California High-Speed Rail Authority

RFP No.: HSR 13-57

**Request for Proposal for Design-Build
Services for Construction Package 2-3**

Book IV, Part G.1 – Design Variance Report

Appendix A – 15% Record Set Drawing SV2262, SV2265, SV2266

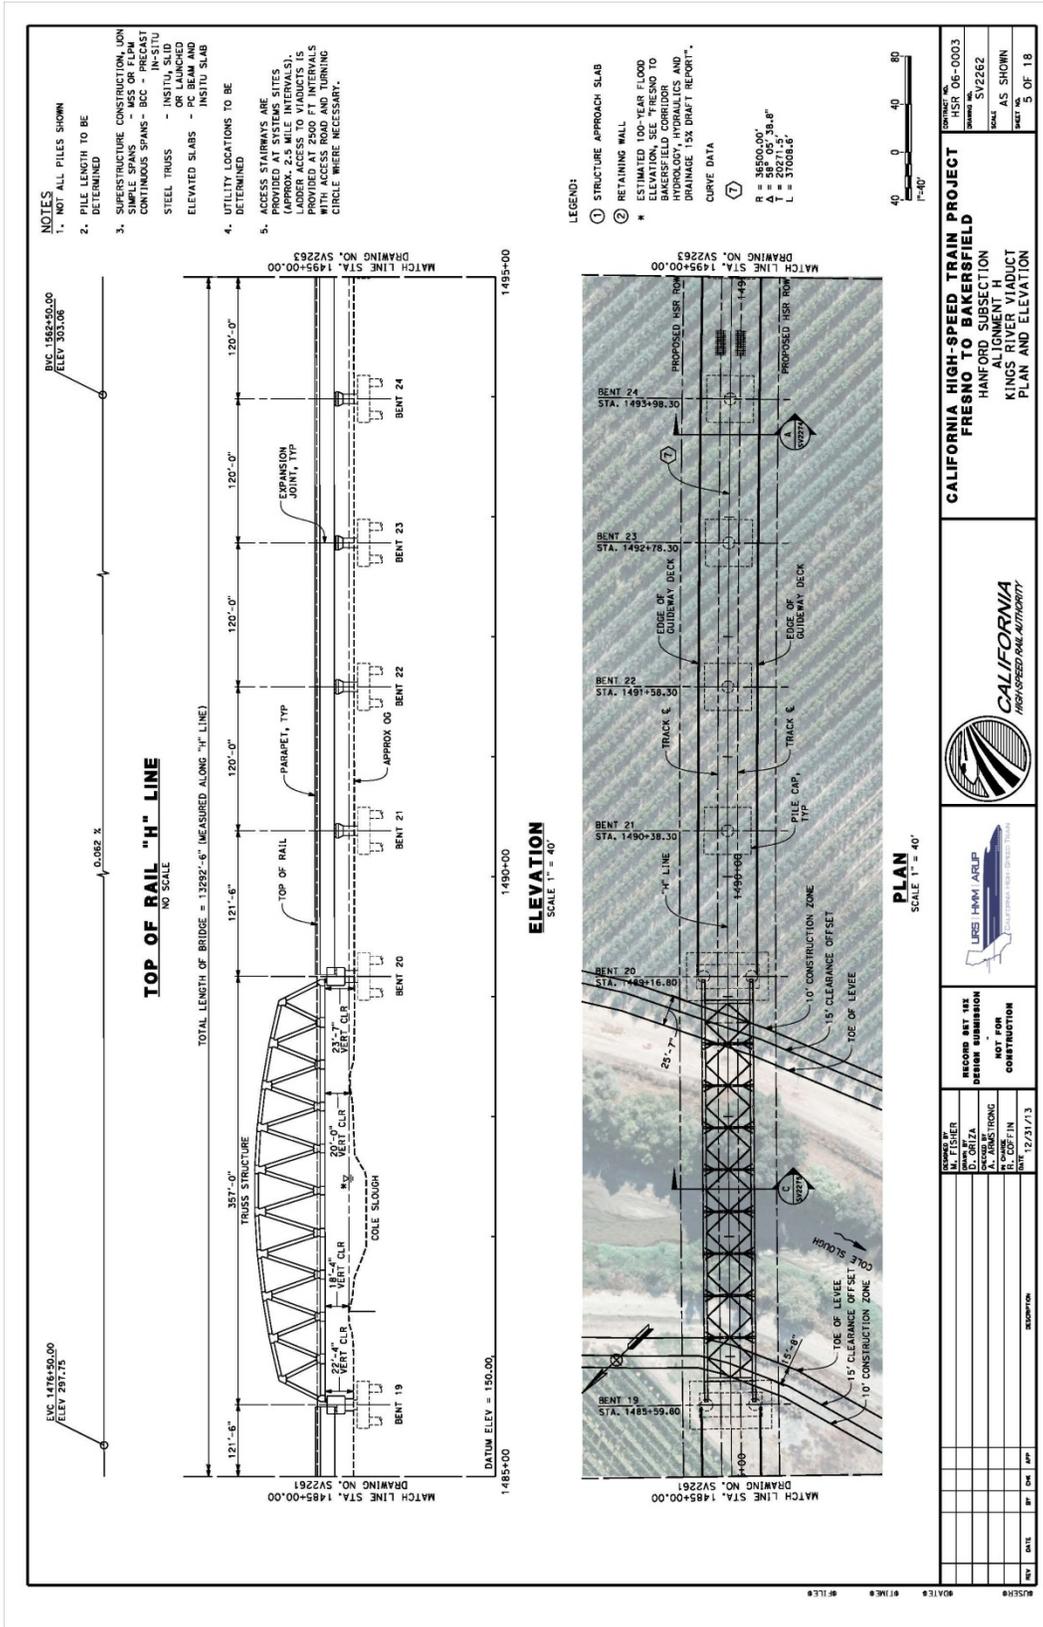
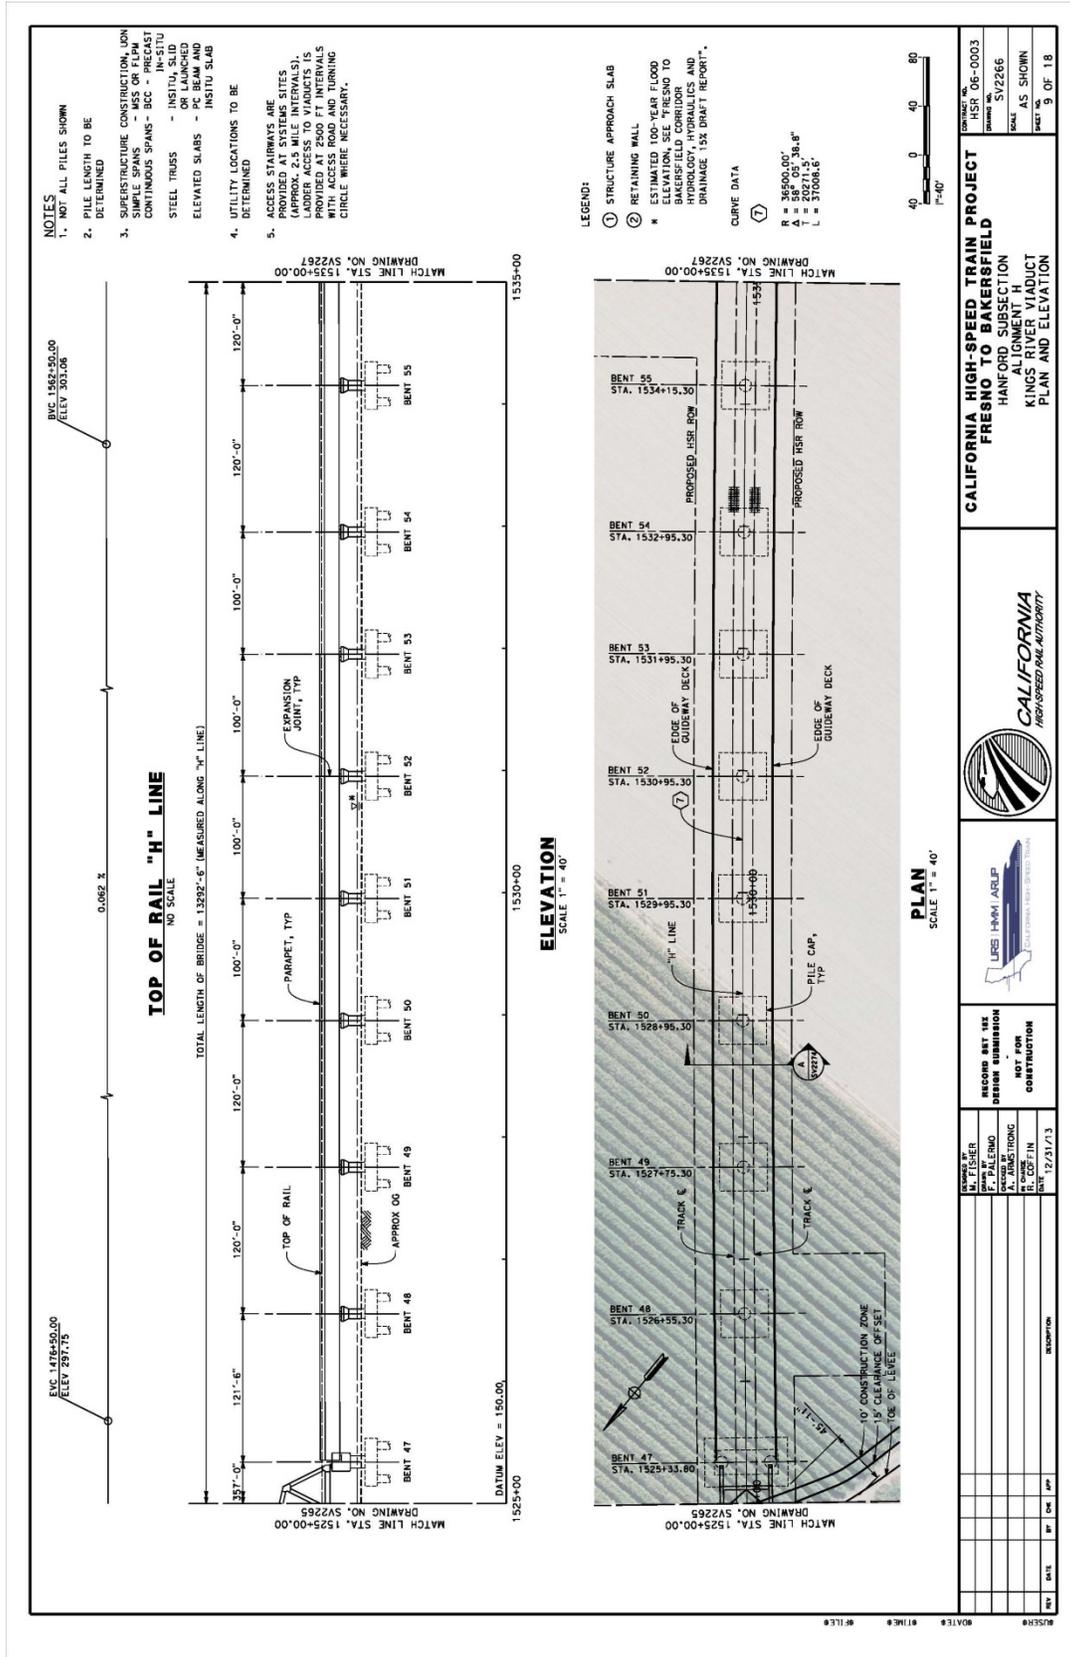
OPERATIONS	There are no operational impacts.
MAINTENANCE	There is no change to the maintenance requirements of the structure or track system.
INFRASTRUCTURE	The effects on the infrastructure of the HSR are expected to be negligible.
RAILROAD SYSTEMS	None identified
RELIABILITY / FUNCTIONALITY	The proposed change is not expected to have any effect on reliability of the system, nor on its functionality.
THIRD PARTY (Utility, Freight, Caltrans, RR, other)	None identified.
SAFETY AND SECURITY	None identified.
DIRECT COST	<p>The cost of a truss span is approximately double the cost of the standard viaduct (\$M/mile).</p> <p>The additional cost of a 350 foot span compared to a 330 foot span is therefore approximately equal to an additional 20 feet of standard viaduct.</p>
OTHER	None identified

Appendix A – 15% Record Set Drawing

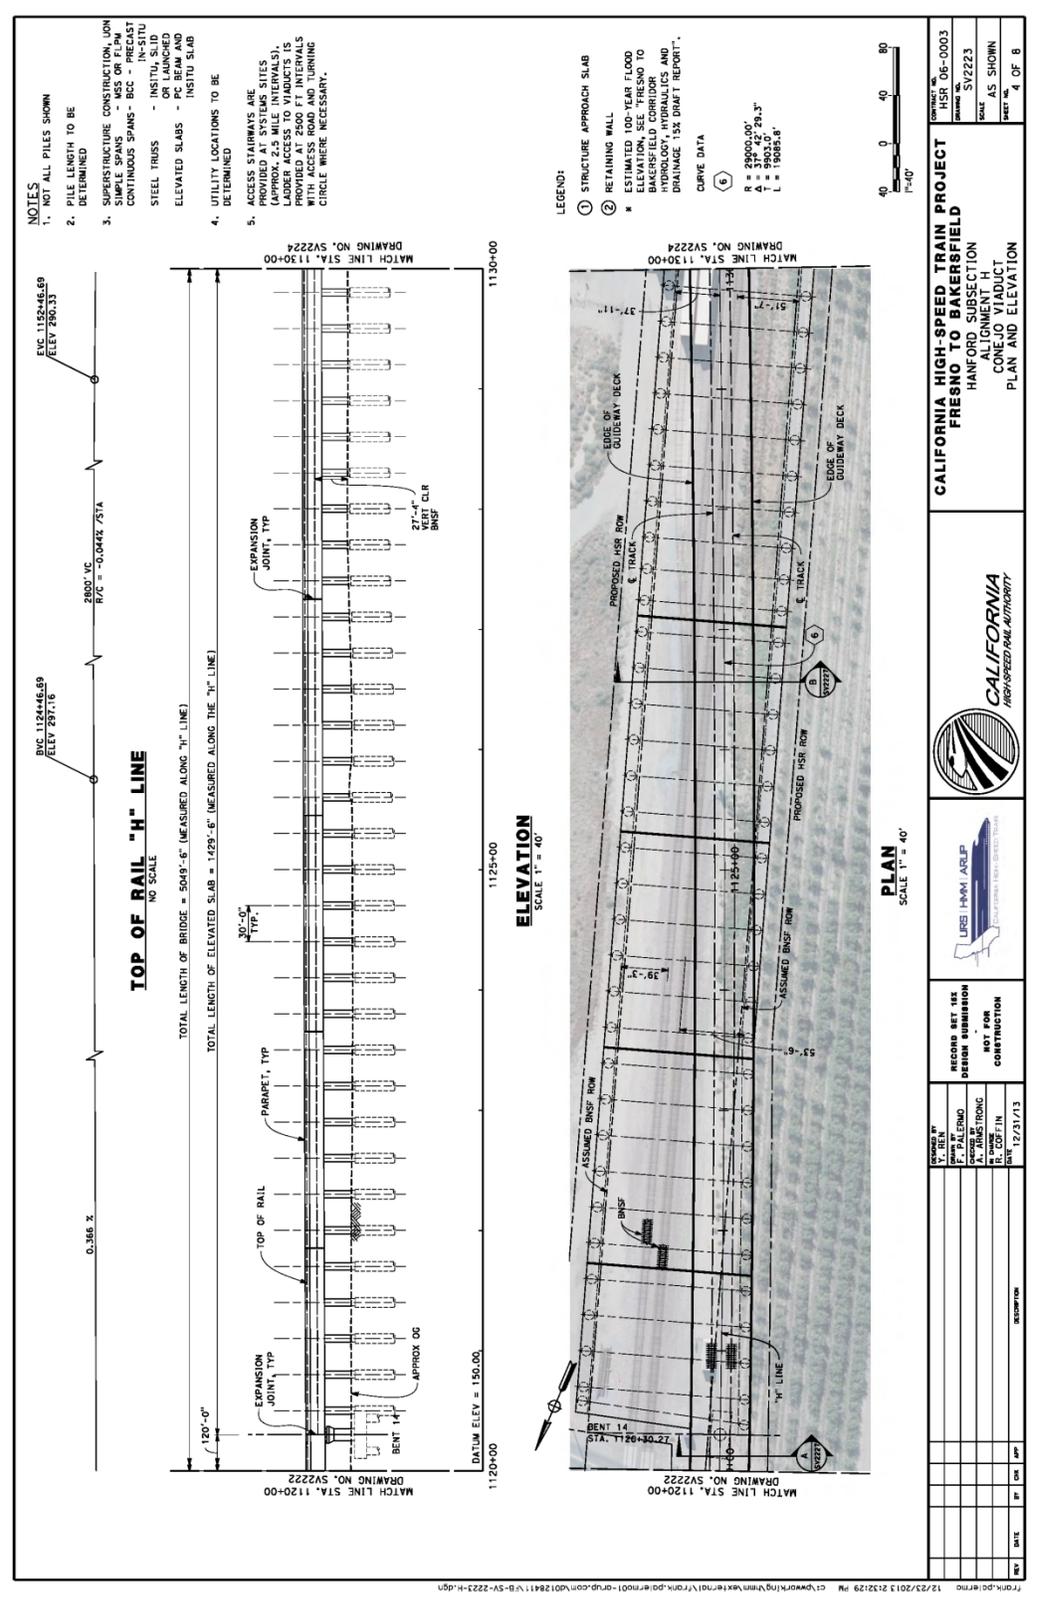
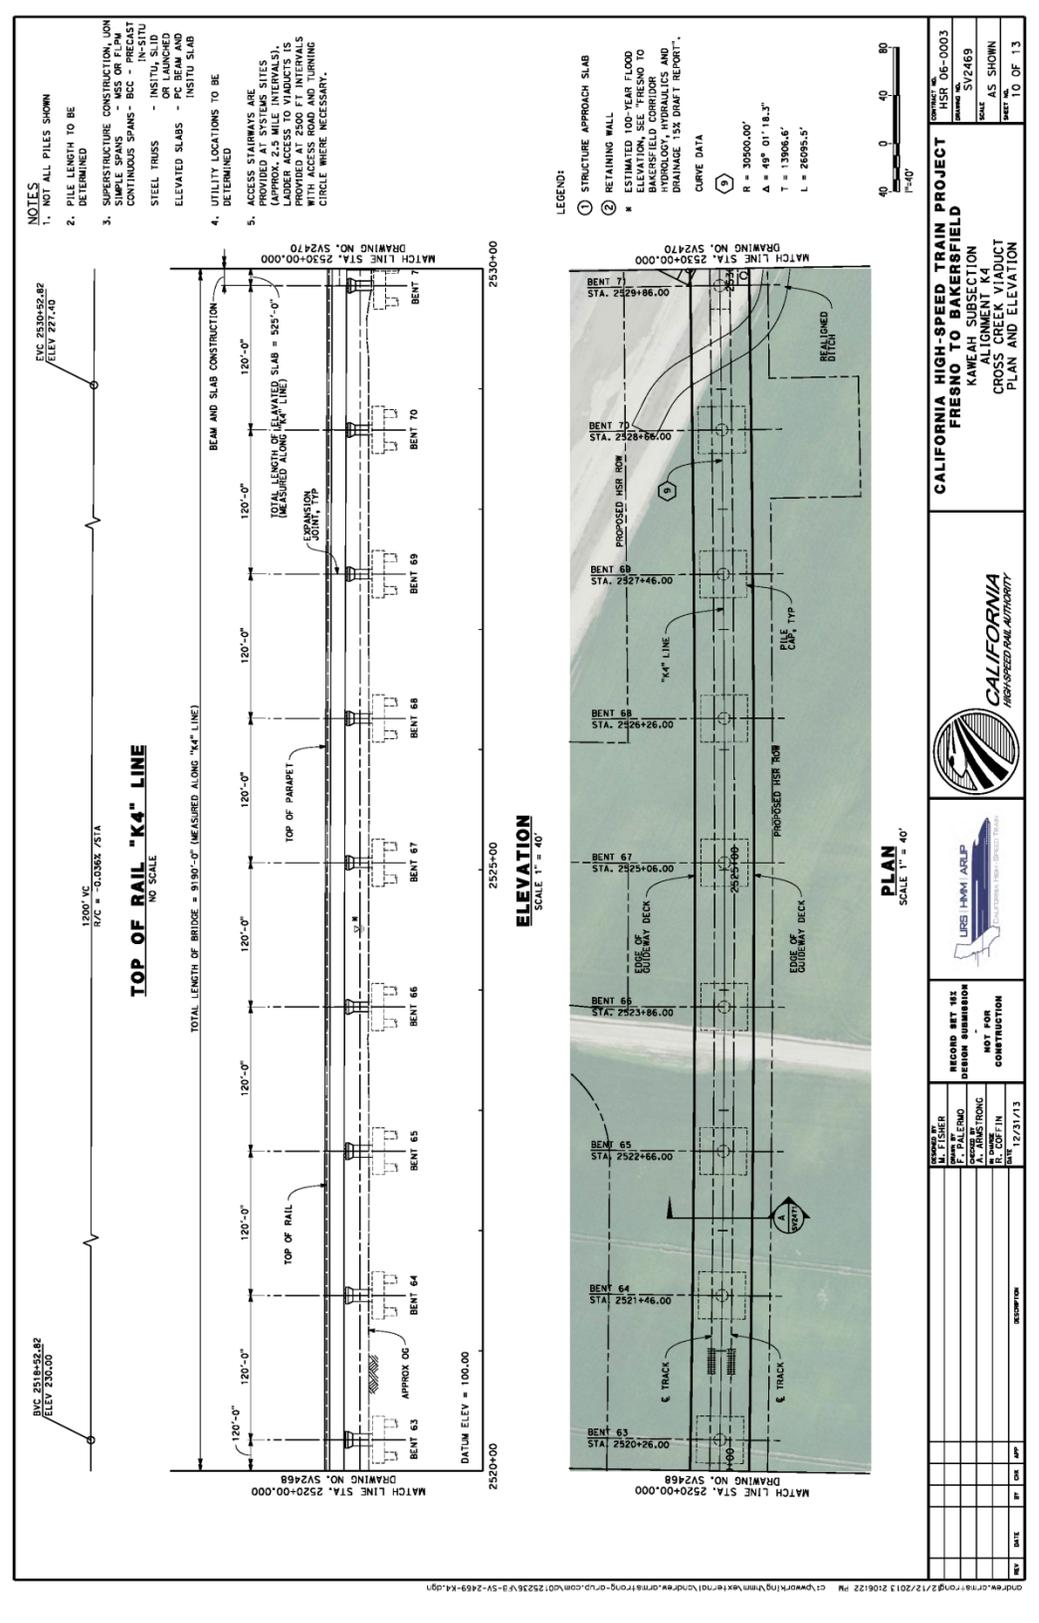
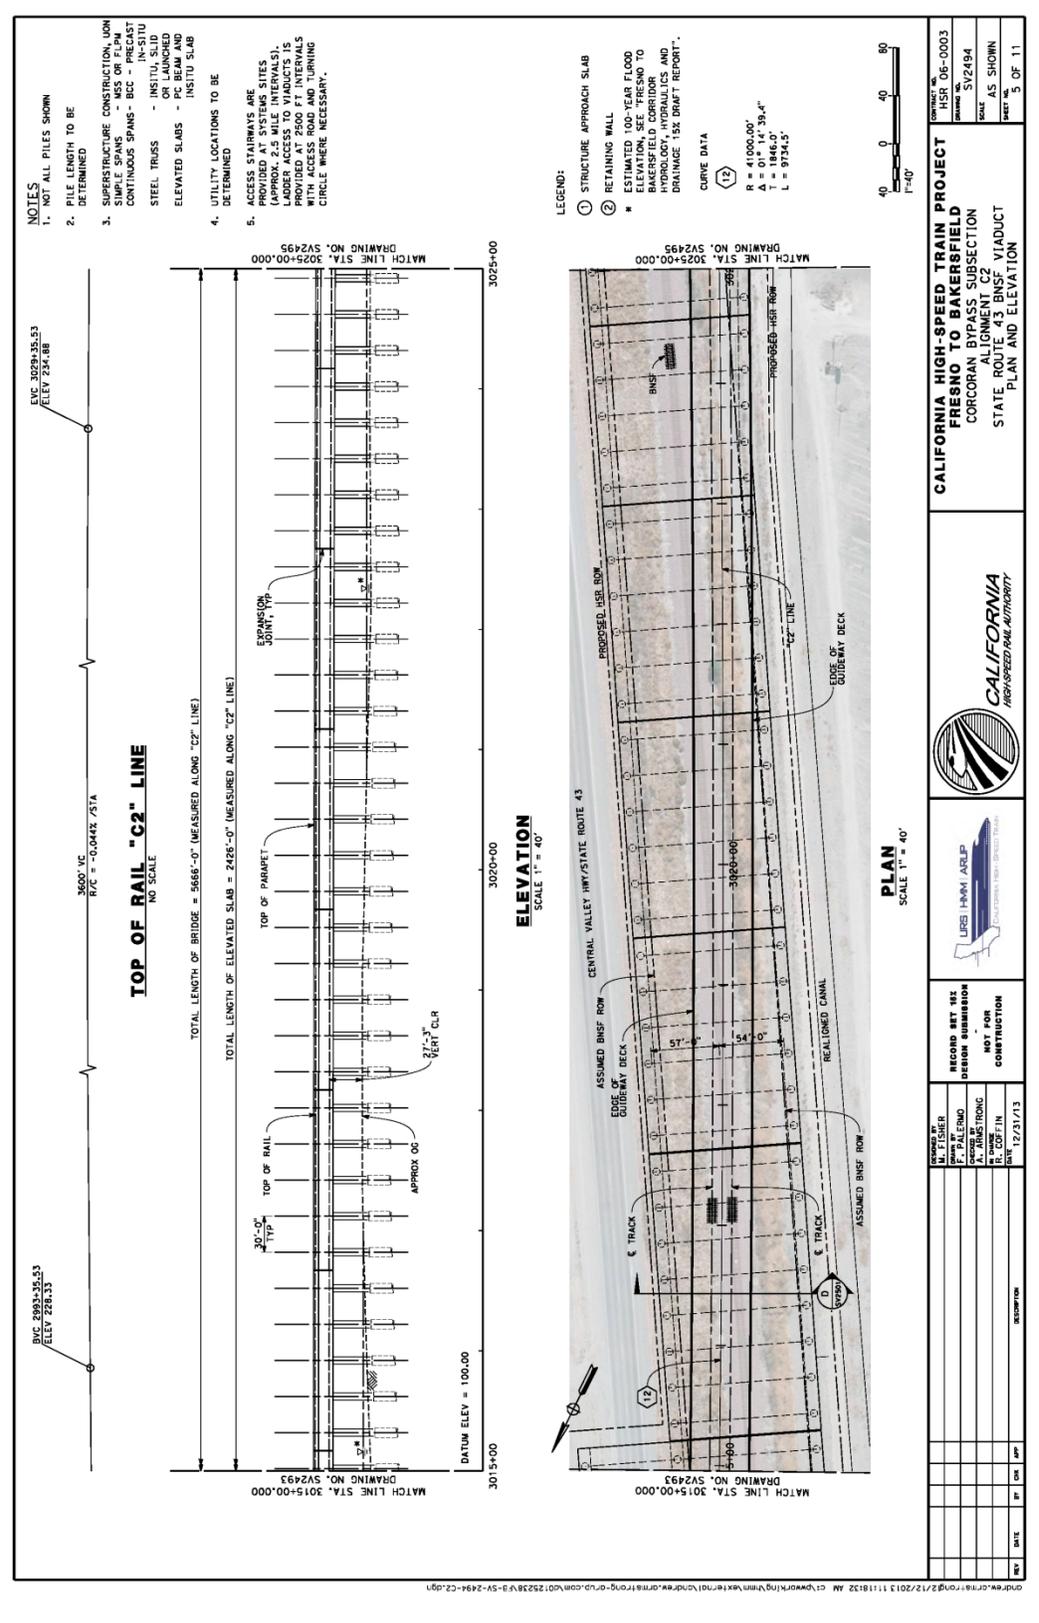
Title/Subject: Substandard maintenance clearance at crossover structures.
